Strategic Infrastructure, Planning & Construction

SUBJECT: Questions #1
RFCSP752-25-1012CS
Kerr Dining Hall Renovation

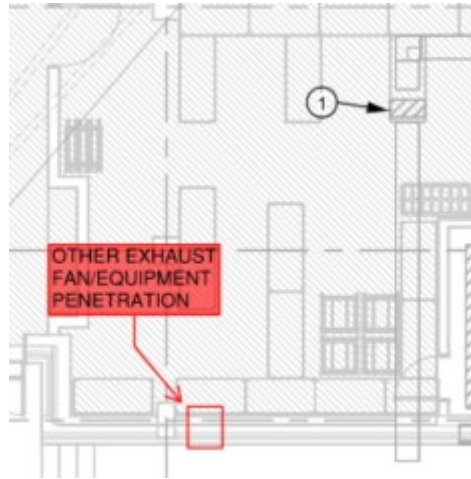
4. Please provide the product information for the quarry tile (TL-9) indicated in Alternate #2. Spec section 093013-2.02-I indicates TL-9 to be porcelain square floor tile and to refer to sheet A700 for the basis of design. TL-9 is not listed in the finish schedule on sheet A700. Please clarify what type of tile is to be used for TL-9 and provide the basis of design.

TL-9 basis of design is Crossville Color Mingles R001 – Grey Mingle, in a Cross Tread pattern, 12”L x 12”W. Alternate applies in all locations where EP-1 is called for. Sheet 700 has been updated in Addendum 4.
